Clinical Change Letter

→ Digital Program Change in InBody770

Model	Program Version	Date of Implementation
InBody770	770DM-0430	23.07.17

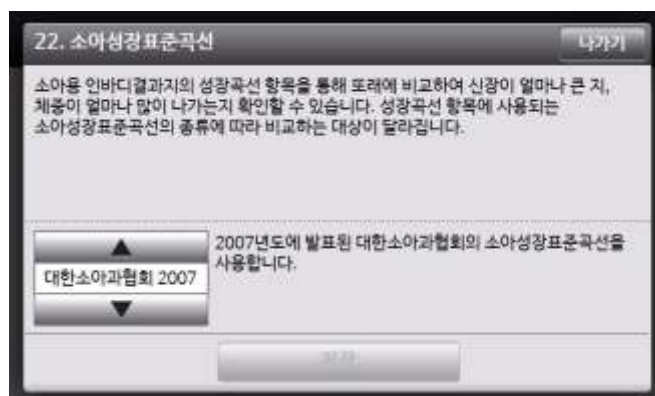
1) LCD : Deletion of Mexican Growth Chart Standard in Spanish setting

- Decide to delete Mexican standard of Growth chart, which turns out to be the same as CDC2000
- CDC2000 will be automatically set as a default in Growth Chart
